DATE: 6-18-93

SUBJECT: Pressure Adjustment of Link Tilt Cylinders

SERIAL NUMBERS: 007

CONT'D FROM D-4-698-1-1

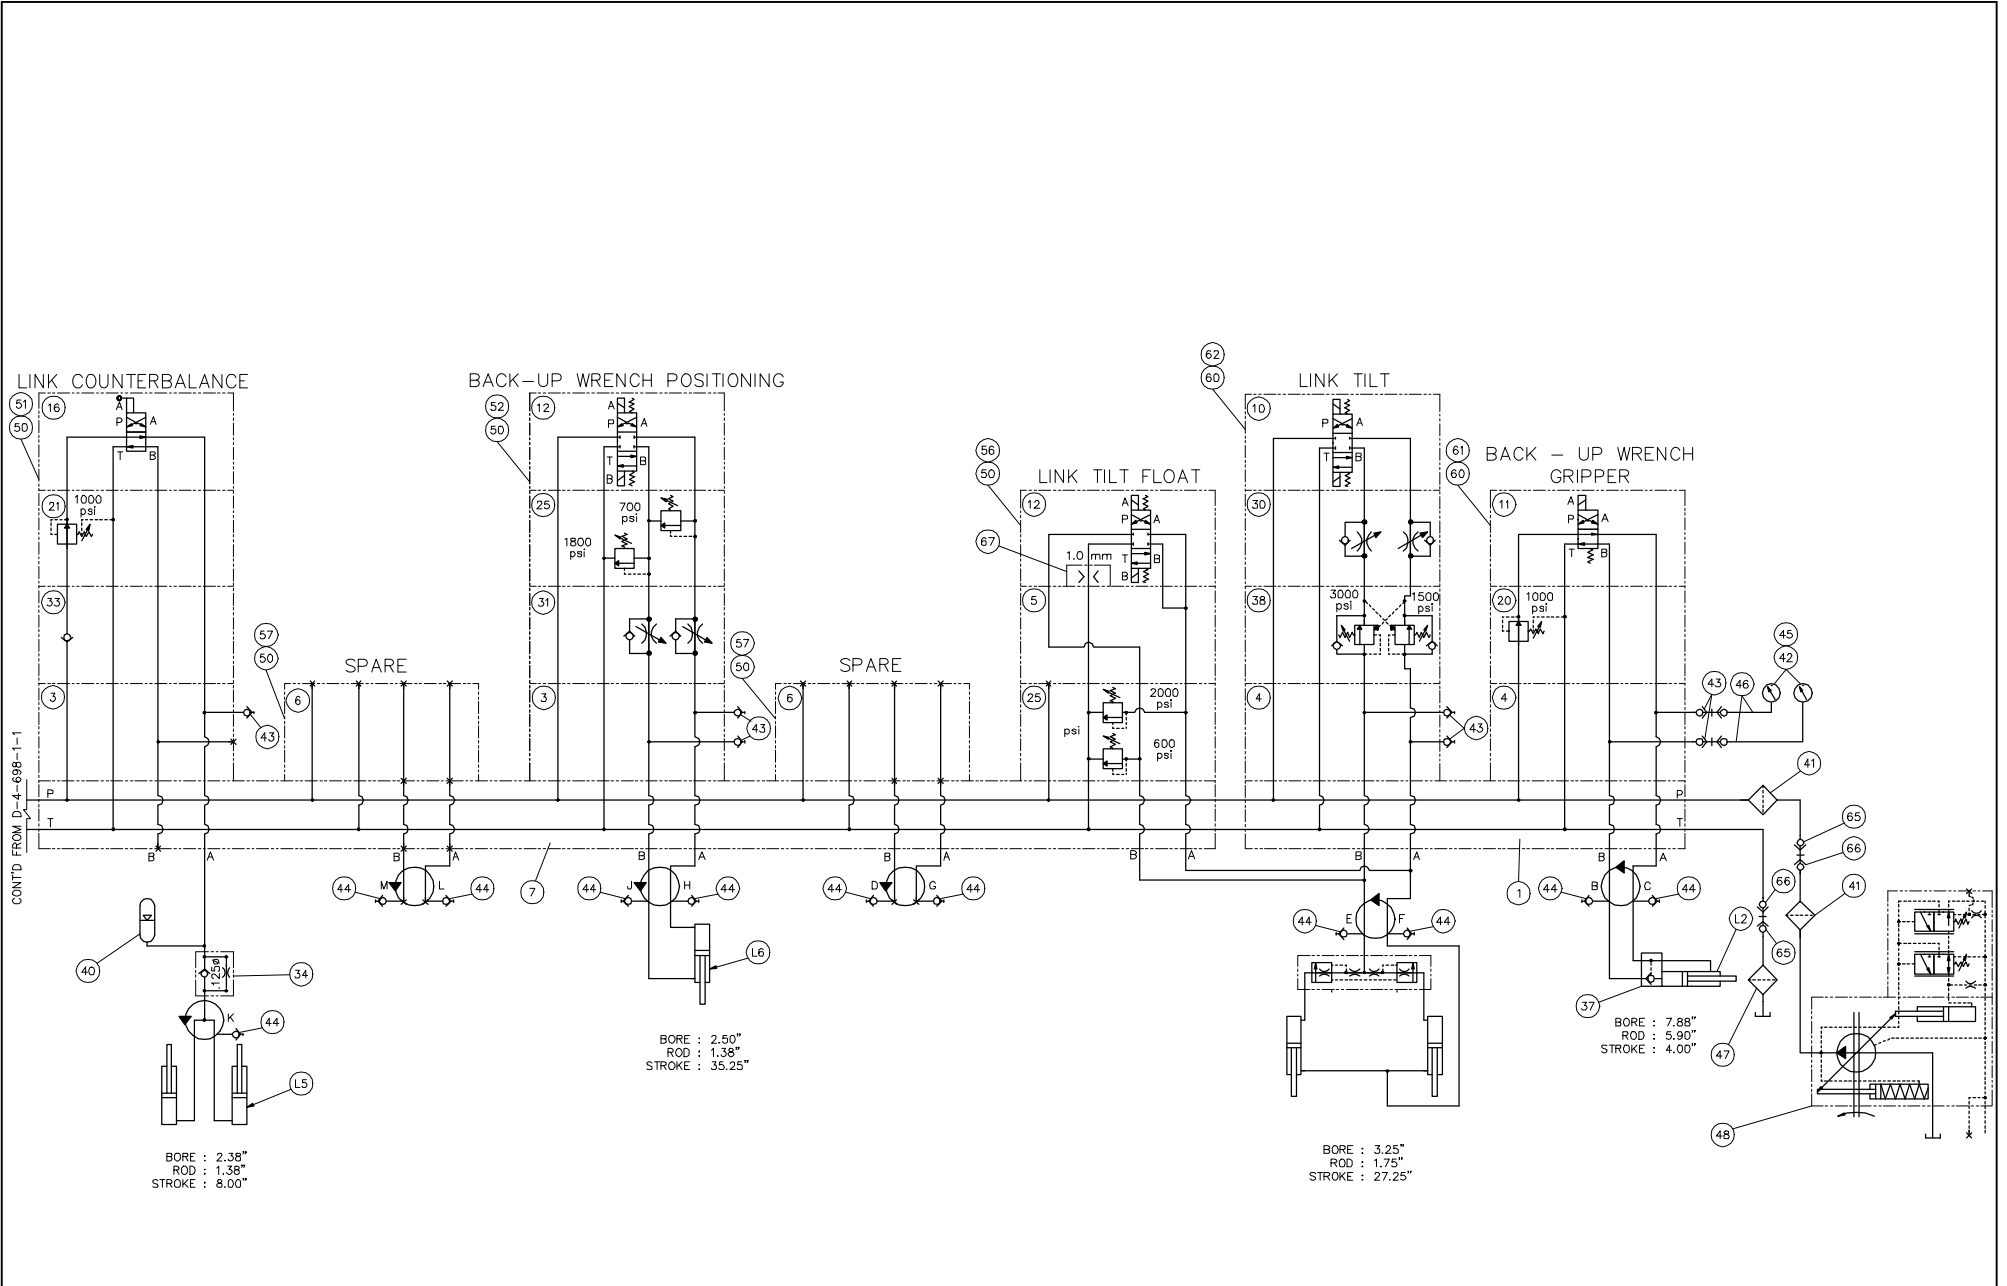
- iv) If the pressure setting is correct no further action is required. If the pressure is not correct continue with this procedure
- v) Locate the Link Tilt Float valve stack on the top drive. (See Parts Book drawing D-4-698-001-2 in Section 5 of the Parts Book) It is located on the off drillers end of the five valve bank (the middle bank).

- vi) The relief valve is the lowest valve on the stack. (i.e. adjacent to the manifold). It has an adjustment on each side, which is probably covered by a plastic cap.

- xi) To summarize, the extend relief setting should be 600 psi and the retract relief setting should be 2000 psi.
